CERTIFICATE OF APPROPRIATENESS

HPO File#: HP2025_0181

Property: 7718 Glenbrae Street, Glenbrook Valley

Proposal: Alteration -

1 SITE PLAN
SCALE: 1/8"=1'-0"

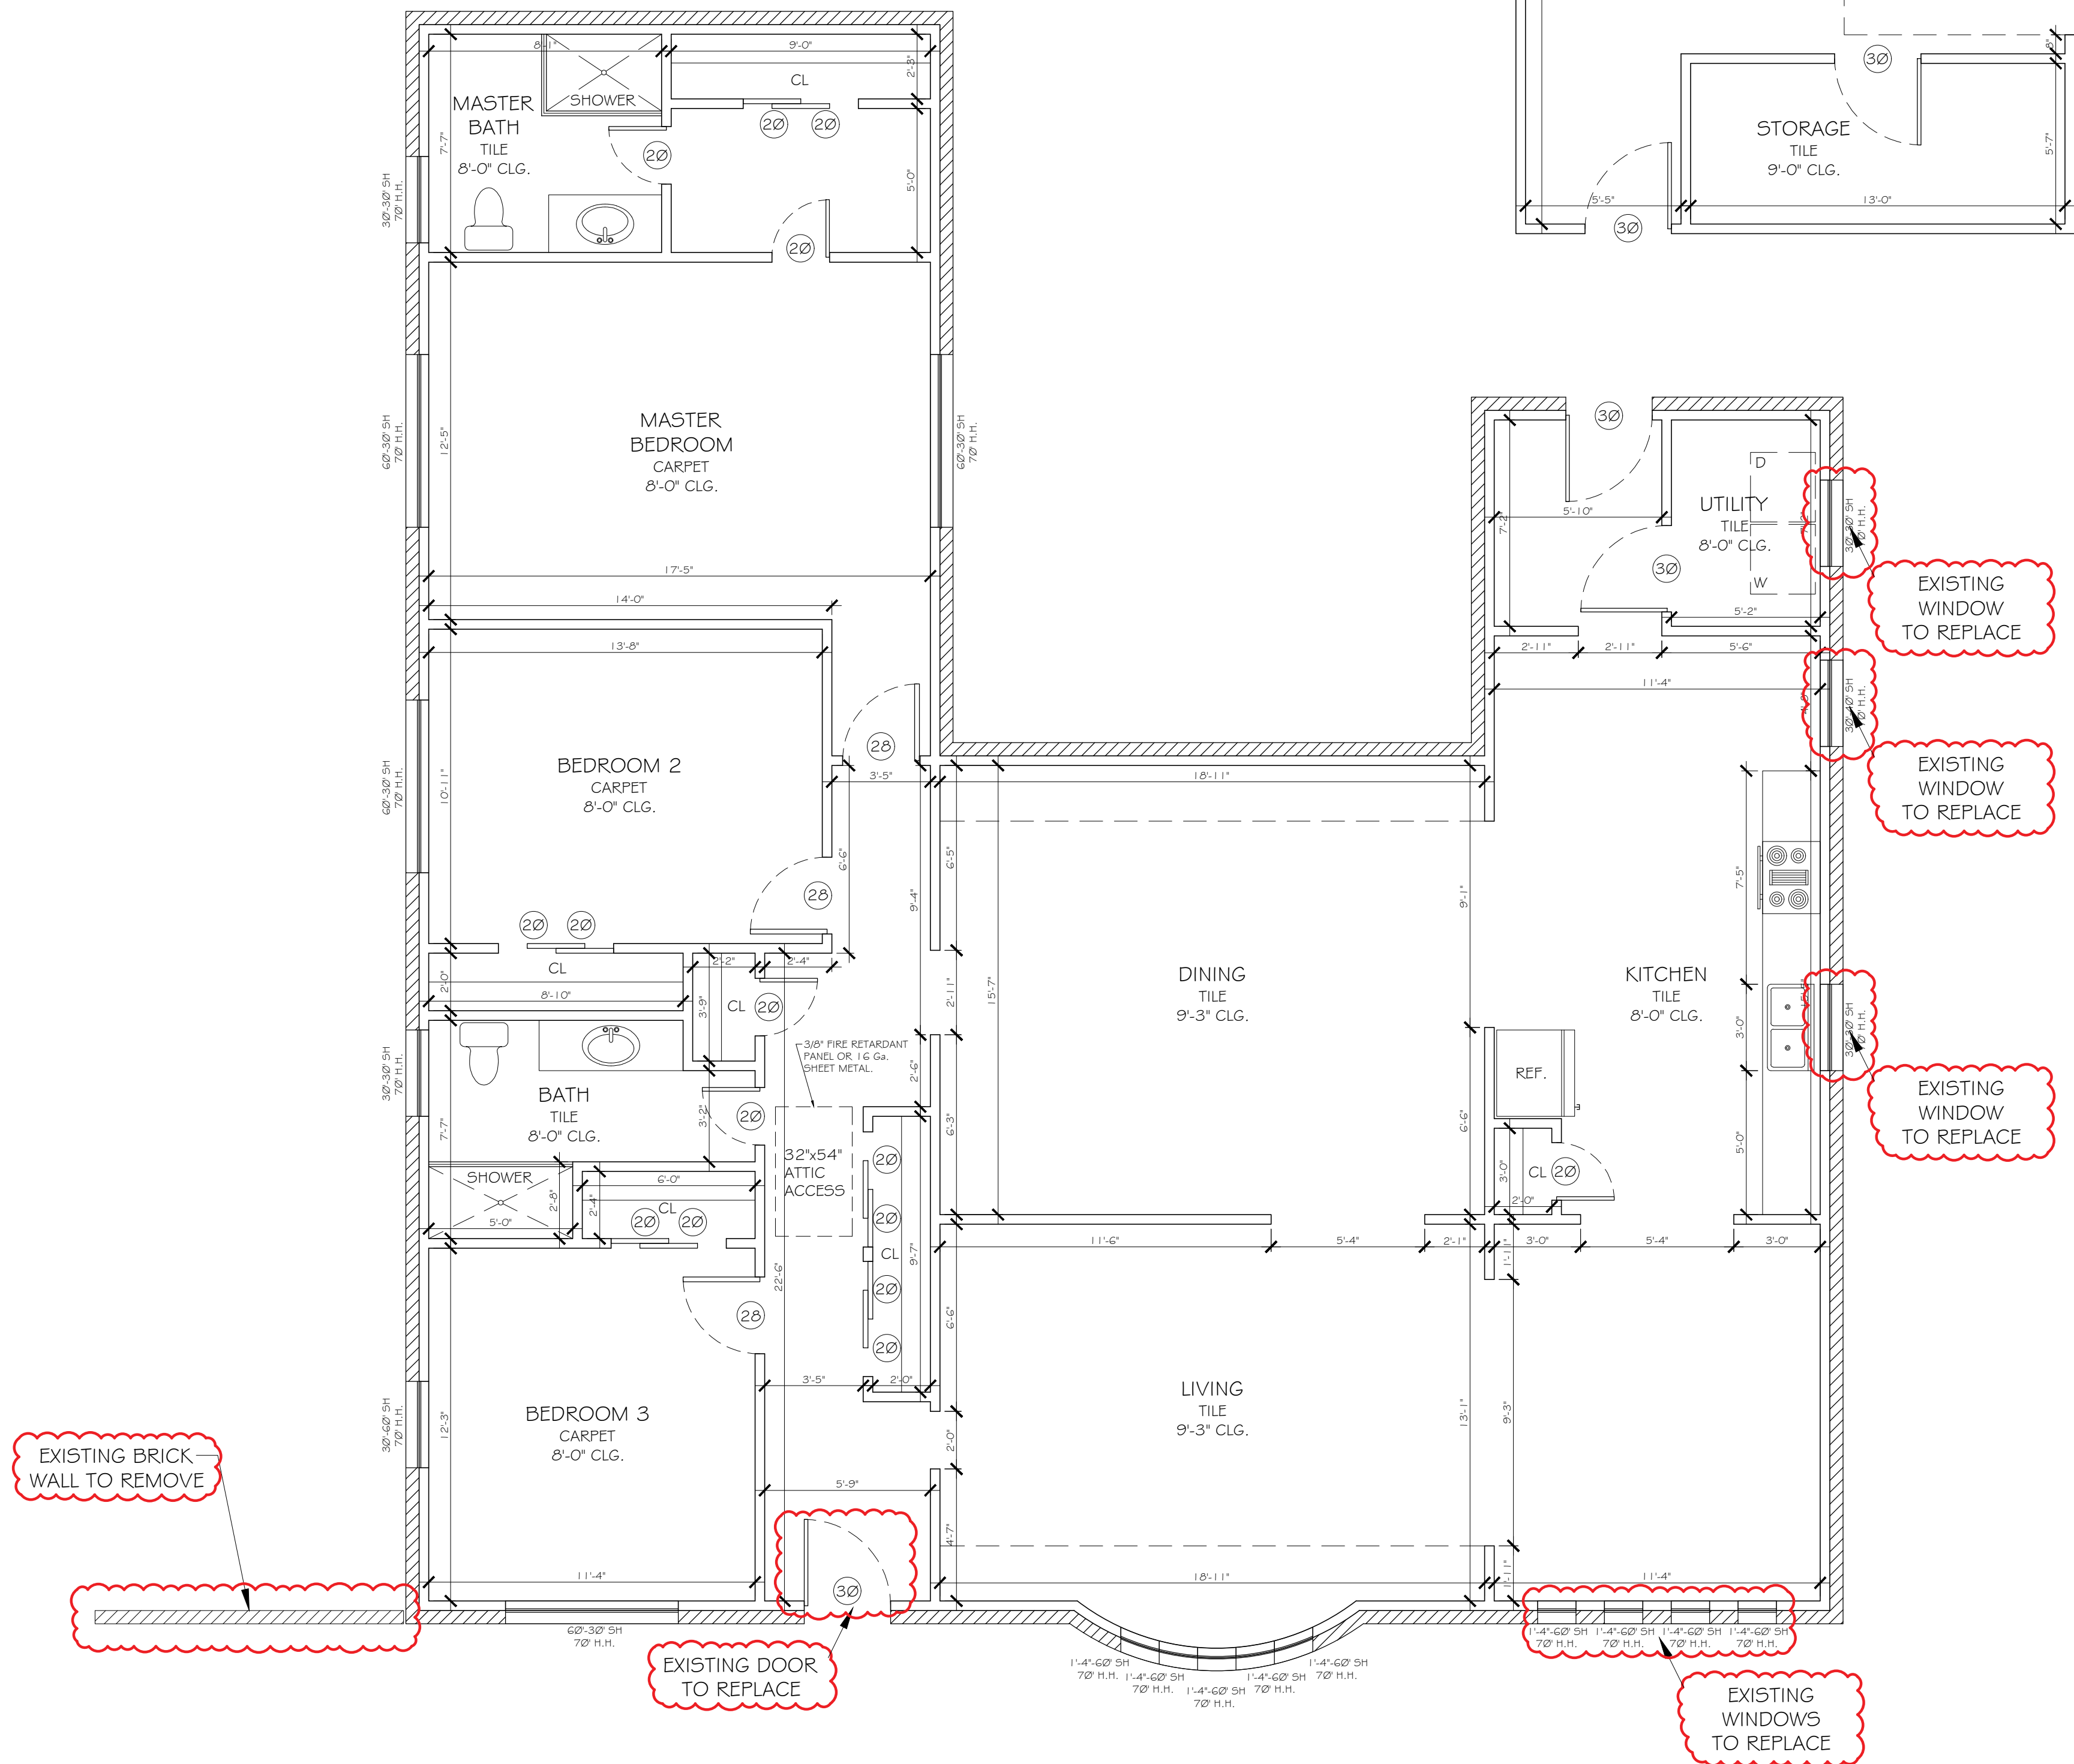
- Proposed Siding Must be Wood
- Retain Extension Wall from NE corner of House
- Remove Proposed NE Driveway

2 PROPOSED FRONT ELEVATION
SCALE: 1/4"=1'-0"

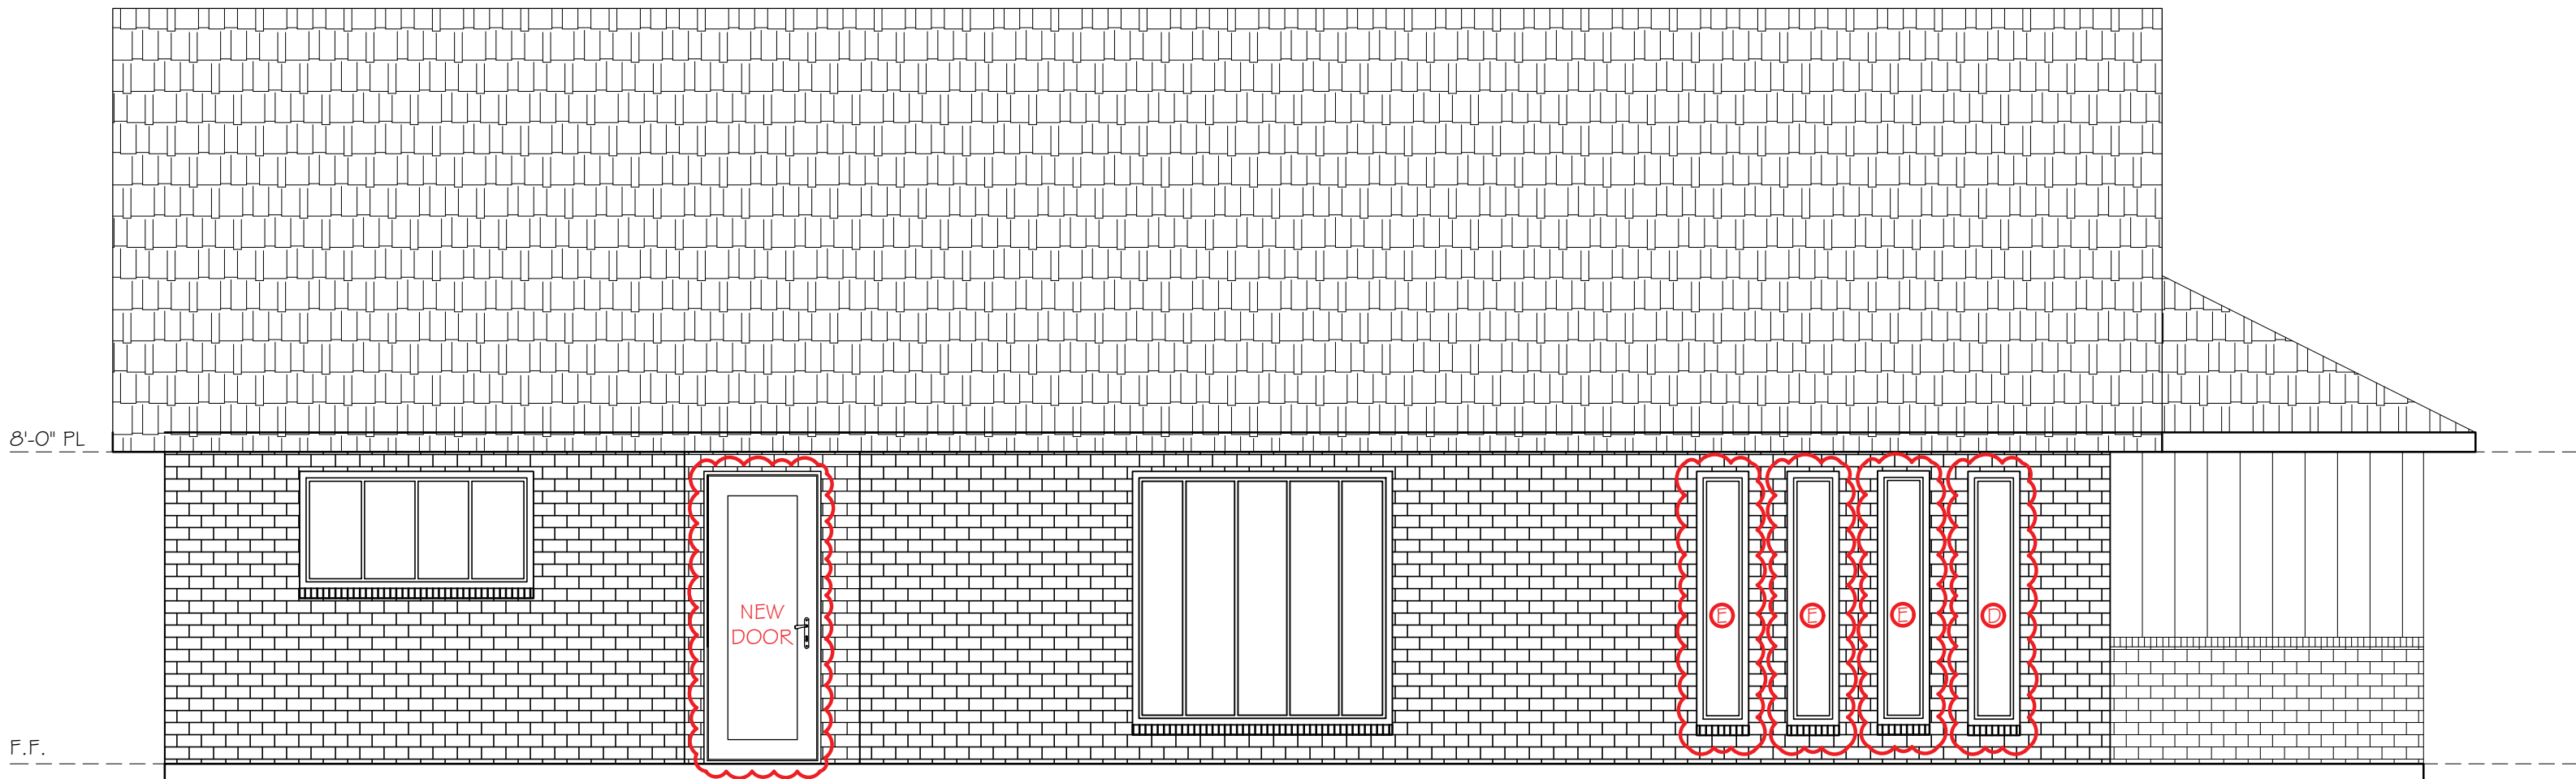
- Replace 3 tall narrow fixed windows, North Elevation
Windows on West Elevation are not working properly and could be dangerous in case of a fire, they are not energy efficient, and I can paint them grayish to match the rest of them.
- Replace 2 smaller windows 1-over-1 single hung (Aluminum Mill Finished), on West Elevation (Aluminum Mill Finish or Gray Vinyl)
- Replace 1 window 1-over-1 single hung (Aluminum Mill Finished), on West Elevation (Aluminum Mill Finish or Gray Vinyl)
Existing windows tall, narrow, vertical, are broken.
- Repair/ Replace existing wood board and batten siding, on West Elevation, South Elevation, East Elevation, with wood or with cementitious boards (wood grain) to match existing board and batten appearance.
- Repair/ Replace existing wood trim with wood or cementitious board (wood grain)
- Replace existing composition shingle roofing with same material.

ALL NEW WINDOWS MUST BE INSET 1¾ Inches – See Attached Window Diagram

1-over-1 Windows Must Be Equally Horizontally Divided

ALL CEMENTITIOUS BOARD MUST BE SMOOTH
